TOWN OF NISKAYUNA
Planning Board and Zoning Commission
Agenda
April 11, 2022
7:00 PM

AGENDA STATEMENT

ITEM TITLE: DISCUSSION: 3713 State Street – Goodyear Tire Store – site plan application for placement of a 20' long x 8' wide storage container on the property

ITEM TITLE: DISCUSSION: 2341 Nott St. – St. James Plaza – site plan application for placement of a Chase Bank ATM in a portion of the Shop Rite parking lot.

This document is the product and property of Baxter-Hodell Domally Preston, Inc. Neither the
for which it was prepared without the written consent of Baxter-Hodell Domally Preston, Inc.
document for the information it contains may be copied or used for other than the specific project

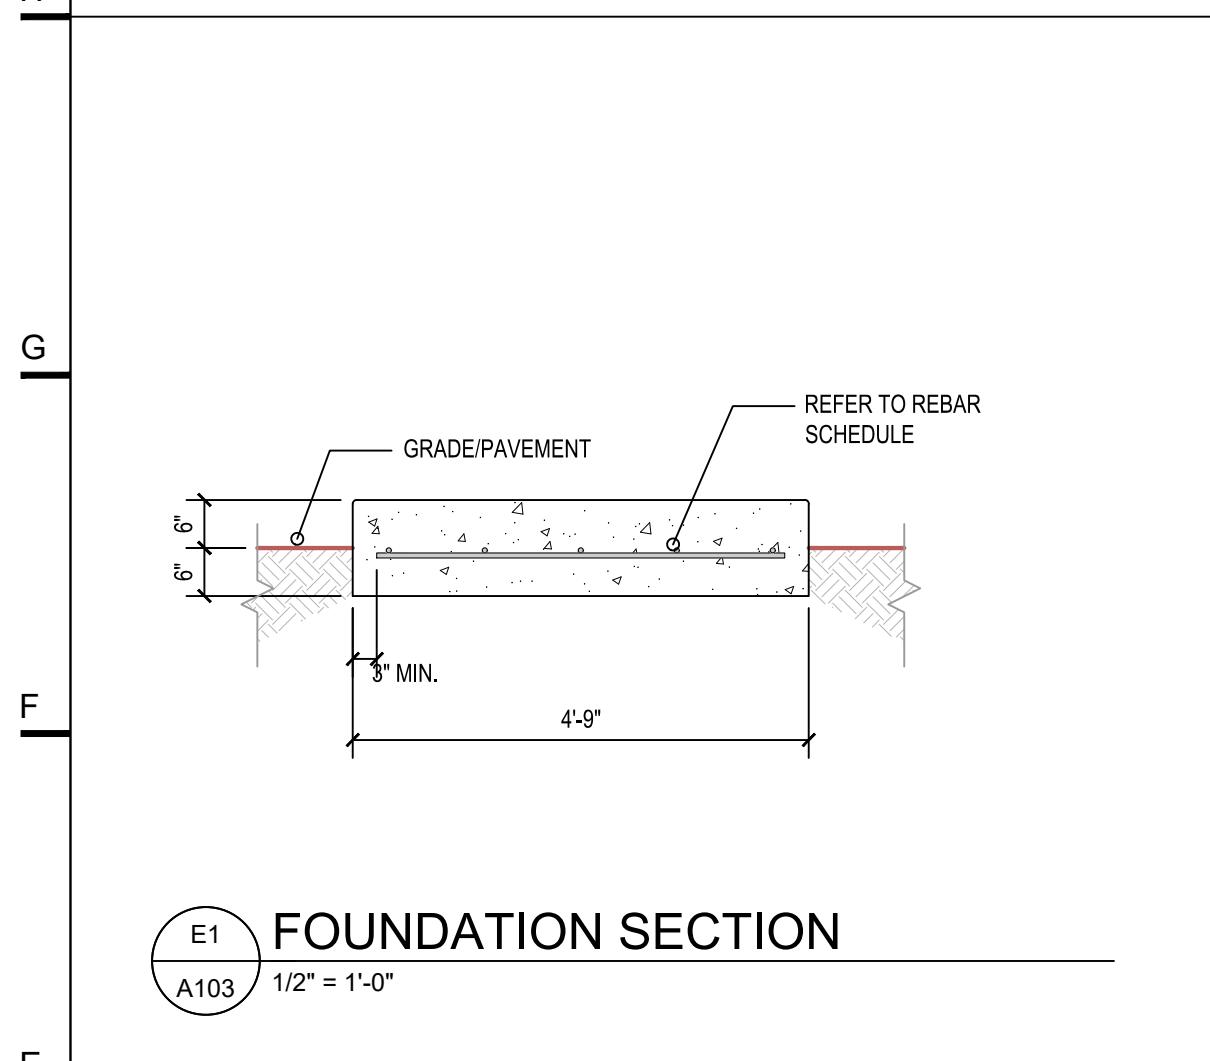
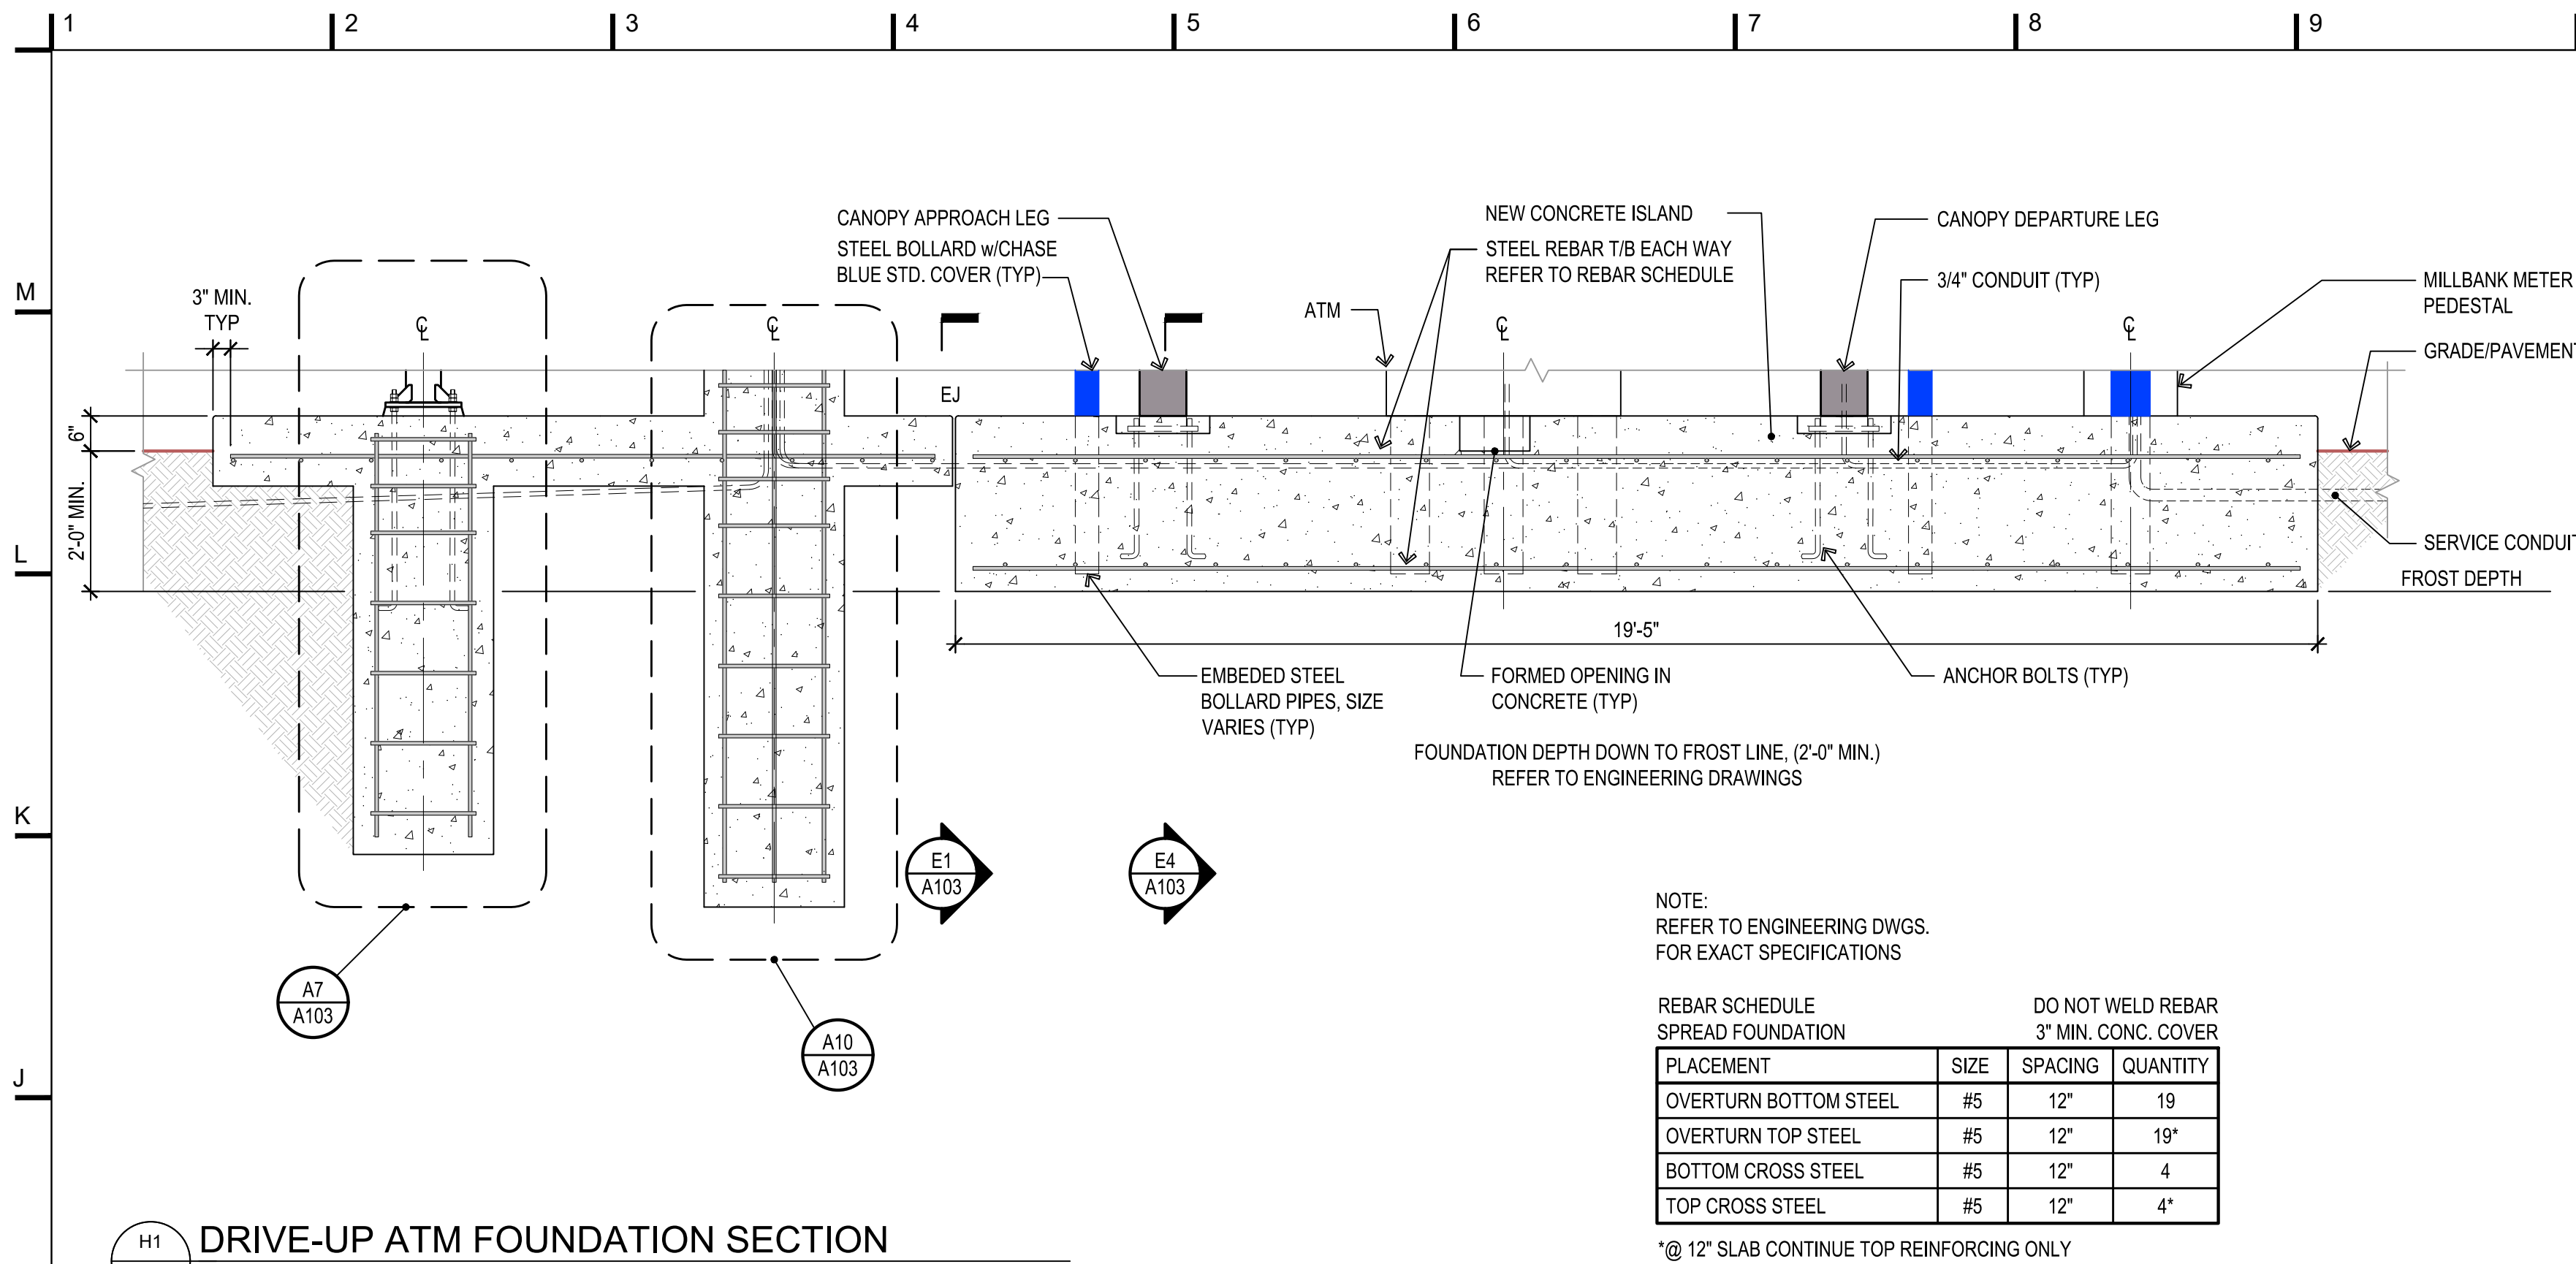
As proposed, page A102 of the drawing set includes a light pole with an area light measuring 23’ high (3’ high concrete base + 20’ high light pole) located at the entrance to the ATM machine. Therefore, a waiver of 1’ (23 – 22) of pole height from finished grade is required.

Pages A102, A103 and A104 of the aforementioned drawing set include design details for the proposed ATM. Several portions of the ATM station infrastructure and associated graphical displays should be reviewed by the Board relative to the requirements set forth in Section 220-4 of the zoning code. The drawings include a "non-illuminated signage option" that reads "CHASE" followed by the Chase Bank logo on one of the canopy legs.
